DrawDiff Comparison Report

Part number: P-001 | Job: af2a6b15-69e6-45db-937c-0a09c2c7cdb9 | Generated: 2026-05-05T01:26:42+00:00

ISO_VIEW_LEFT [MATCHED]

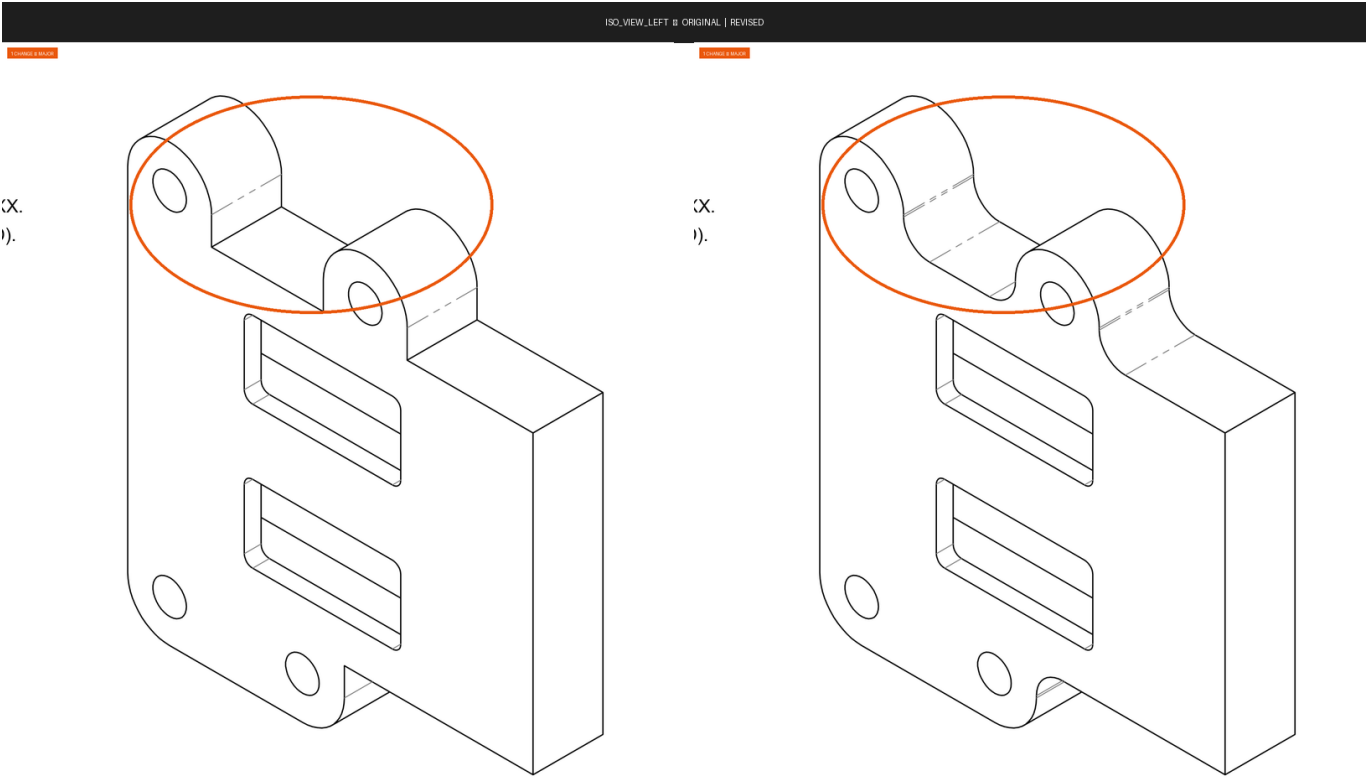
Severity	Field	Zone	Original	Revised	Conf.	Rationale
SIGNIFICANT	geometry	A4	Top hinge/ bracket arm has a flat/straight upper profile with a sharp step transition to the cylindrical boss	Top hinge/bracket arm has a curved/ radiused upper profile with smooth fillet transitions connecting to the cylindrical boss	0.82	The upper bracket arm geometry changed from a flat-topped stepped profile to a smoothly curved radiused profile, indicating a design change to the bracket lug that affects stress concentration and potentially fit/function.

ISO_VIEW_RIGHT [MATCHED]

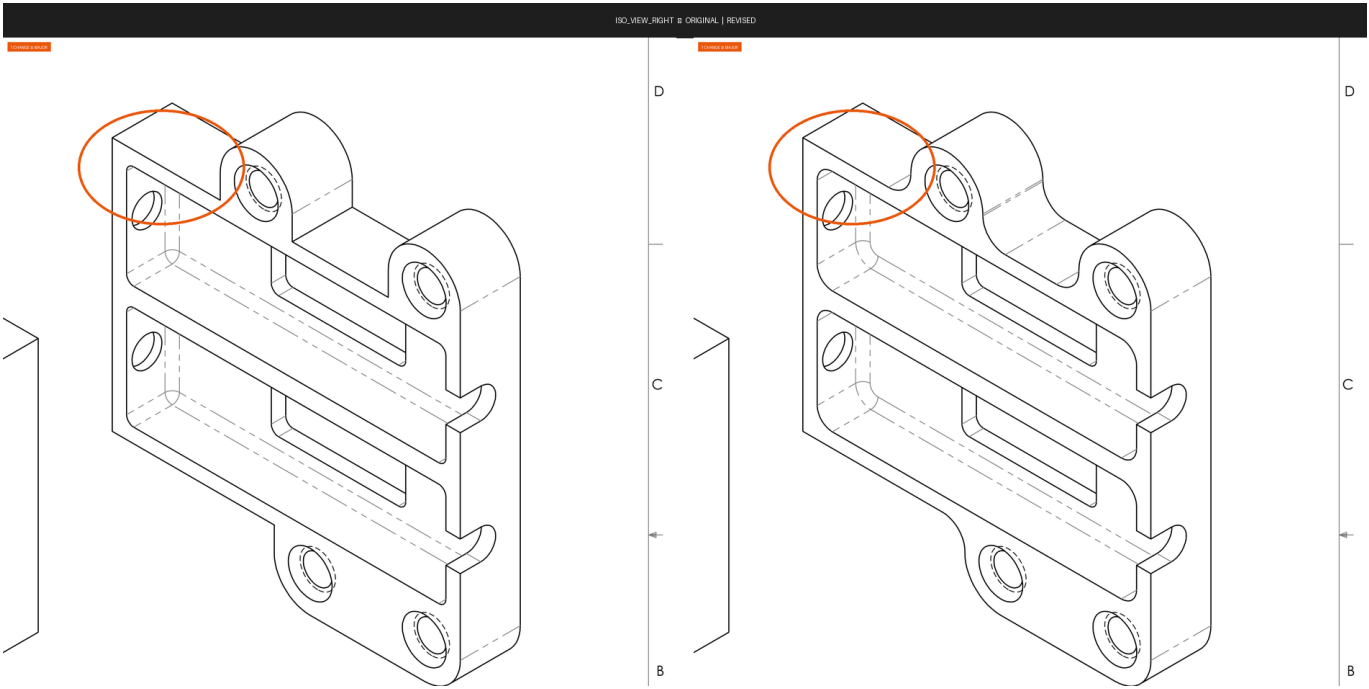
Severity	Field	Zone	Original	Revised	Conf.	Rationale
SIGNIFICANT	geometry	A3	Square/sharp upper-left corner on front face top edge	Chamfered/ rounded upper-left corner on front face top edge	0.72	The top-left corner of the front face plate appears to have a chamfer or fillet added in the revised view, changing the geometry from a sharp corner to a relieved corner.

SECTION B-B [MATCHED]

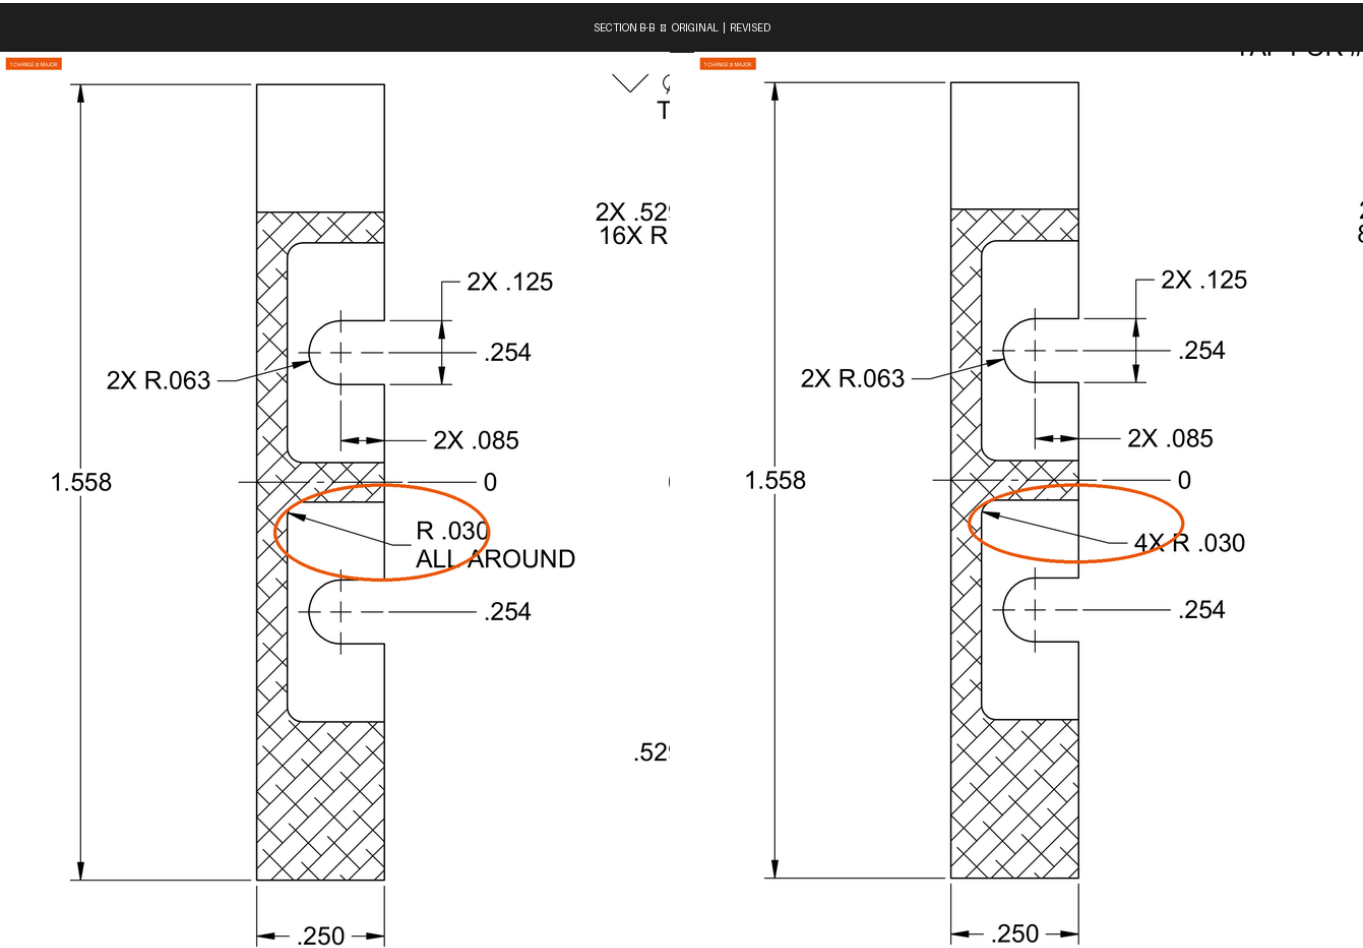
Severity	Field	Zone	Original	Revised	Conf.	Rationale
SIGNIFICANT	callout	B7	R .030 ALL AROUND	4X R .030	0.92	The radius callout changed from 'R .030 ALL AROUND' to '4X R .030', replacing the all-around specification with an explicit count of 4 instances, which changes the scope and interpretation of where the radius applies.

FRONT_VIEW [MATCHED]

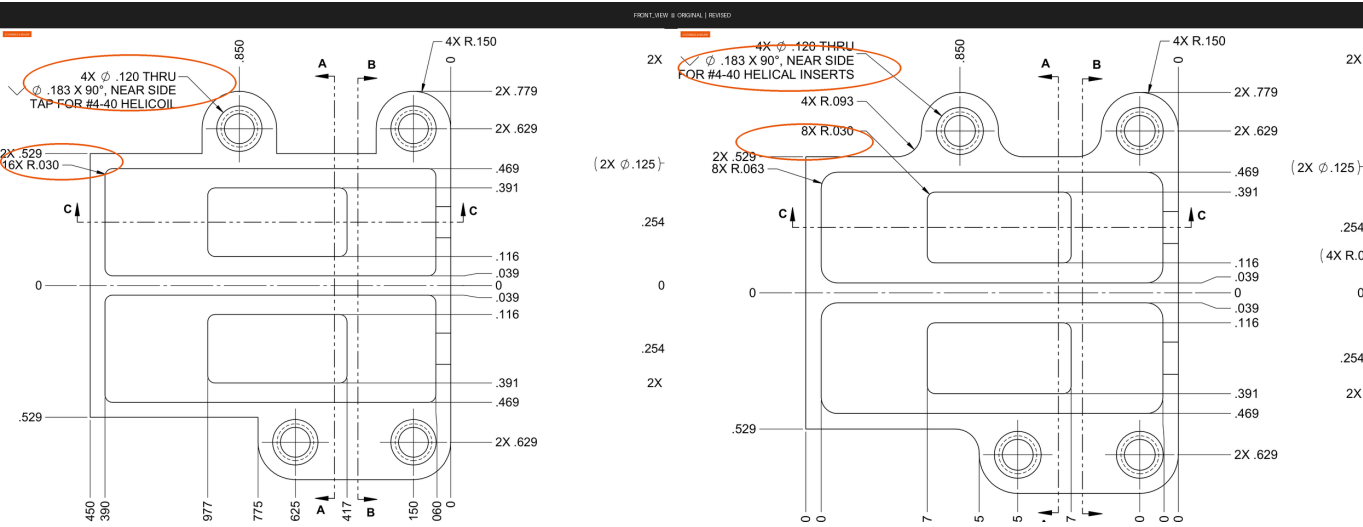
Severity	Field	Zone	Original	Revised	Conf.	Rationale
SIGNIFICANT	note	A6	TAP FOR #4-40 HELICOIL	FOR #4-40 HELICAL INSERTS	0.92	The thread insert callout wording changed from 'TAP FOR #4-40 HELICOIL' to 'FOR #4-40 HELICAL INSERTS', which alters the manufacturing instruction and supplier/brand specification for the threaded inserts.
SIGNIFICANT	annotation	A6	16X R.030	8X R.030	0.90	The count of R.030 corner radii changed from 16X to 8X, indicating a reduction in the number of these radii applied to the part geometry.

SECTION A-A [MATCHED]

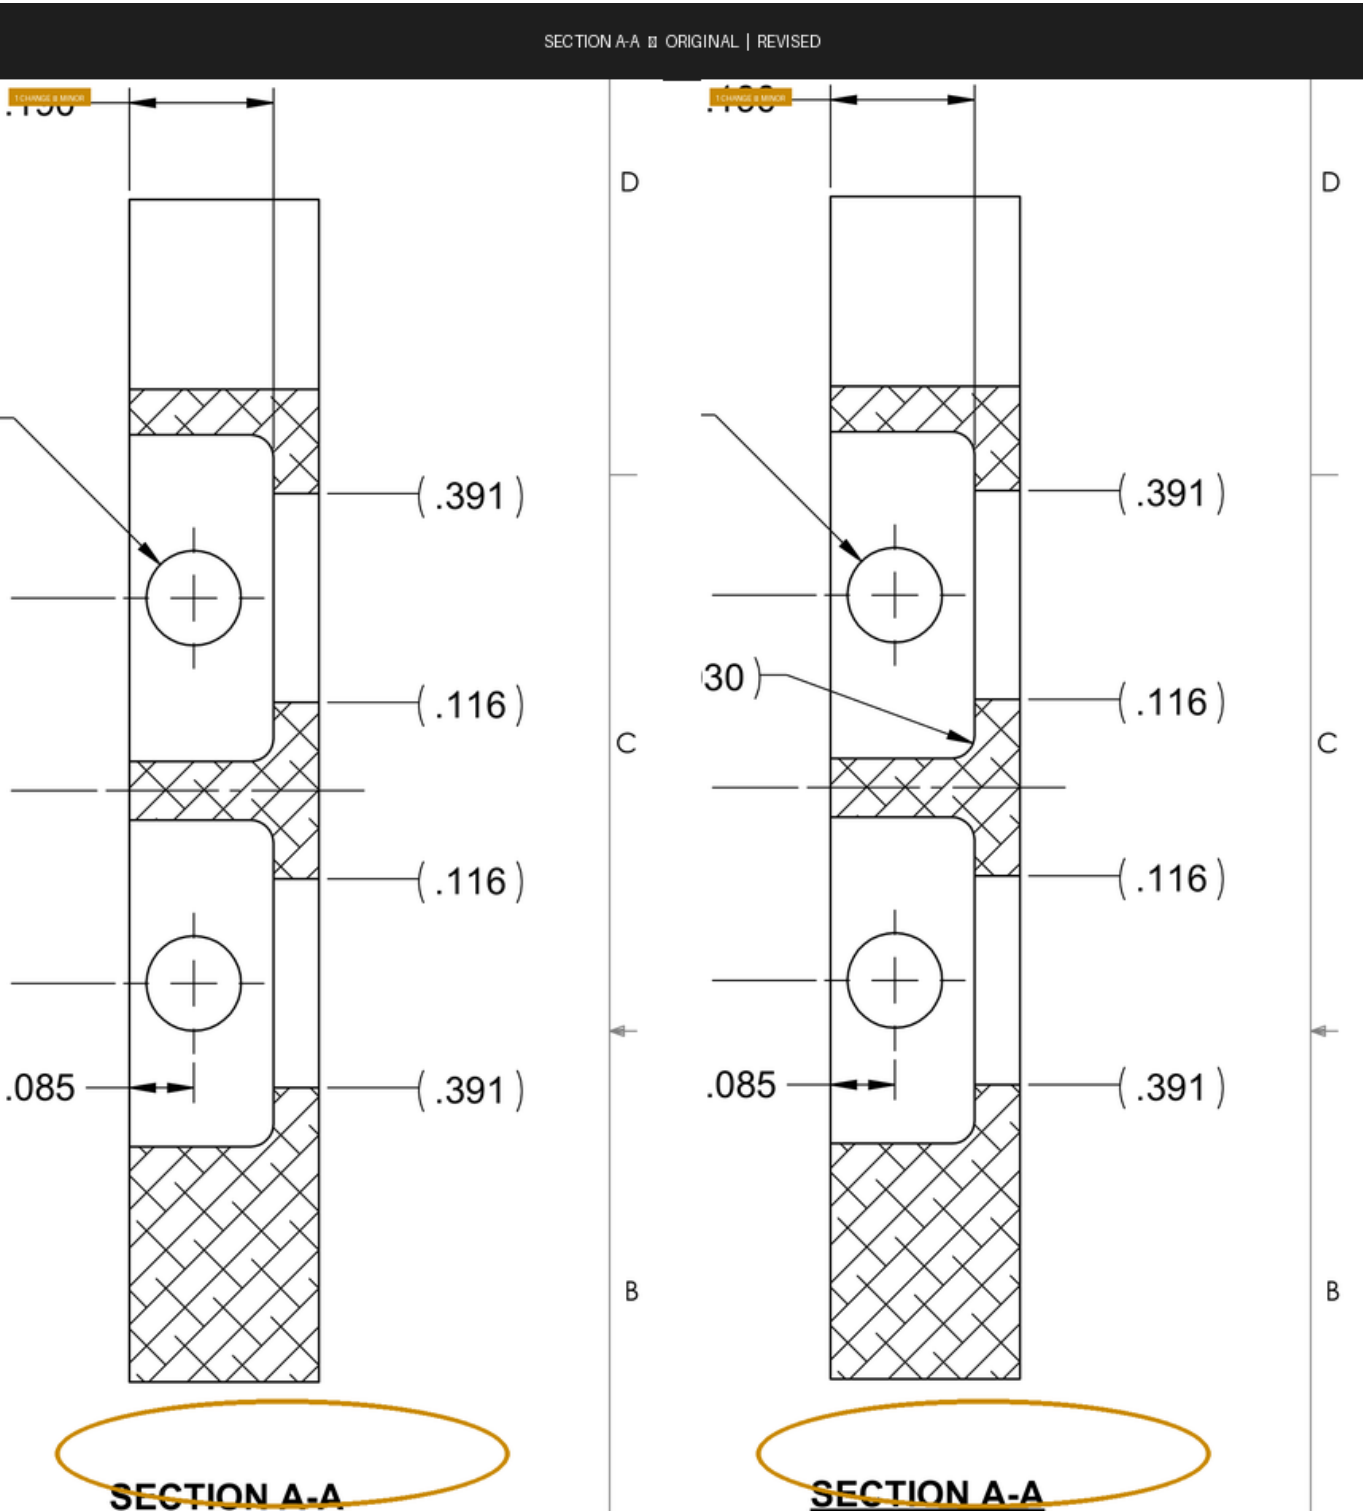
Severity	Field	Zone	Original	Revised	Conf.	Rationale
MINOR	annotation	C1	SECTION A-A (no underline)	SECTION A-A (underlined)	0.82	The view label 'SECTION A-A' appears underlined in the revised drawing but was not underlined in the original, representing a drafting/documentation formatting change.

SECTION C-C [MATCHED]

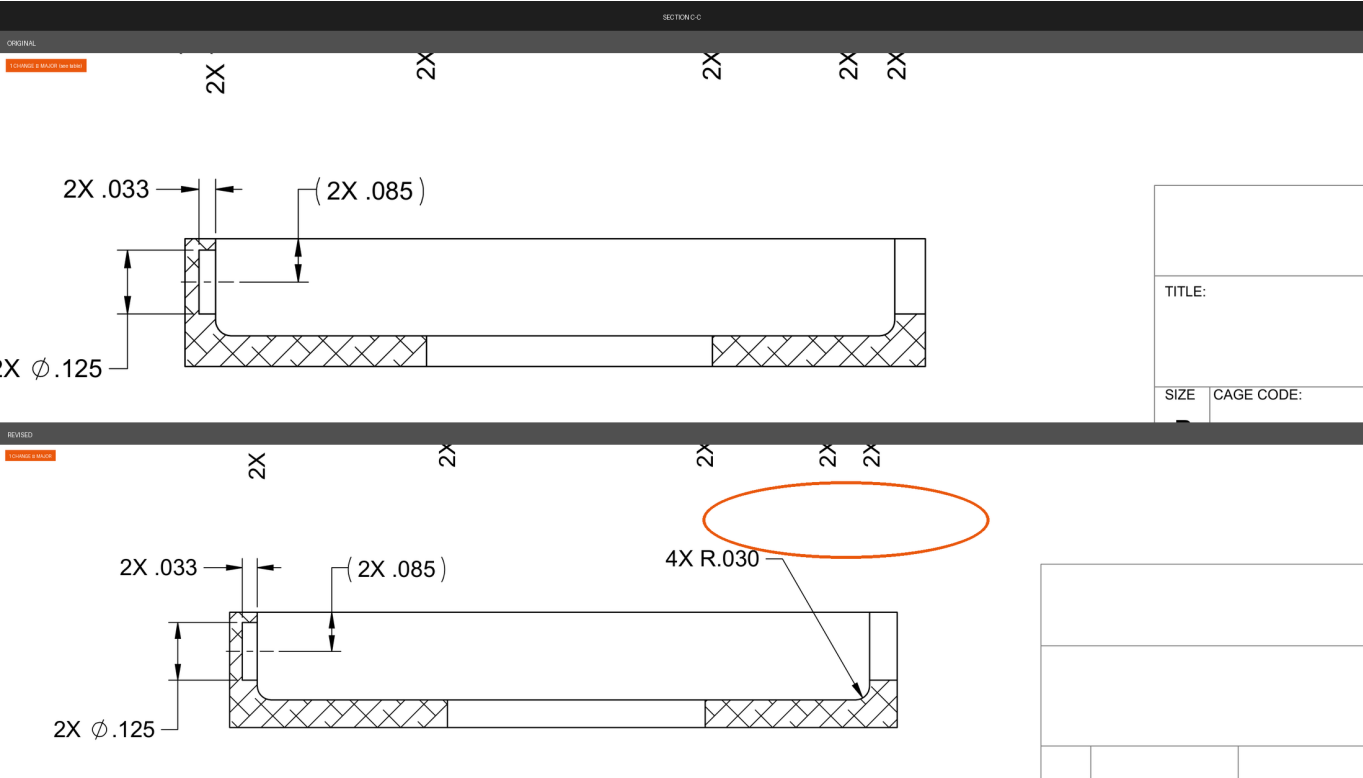
Severity	Field	Zone	Original	Revised	Conf.	Rationale
SIGNIFICANT	callout	D3	—	4X R.030	0.92	A new radius callout '4X R.030' has been added in the revised drawing, specifying corner radii that were not previously called out, which affects manufacturing and part geometry.
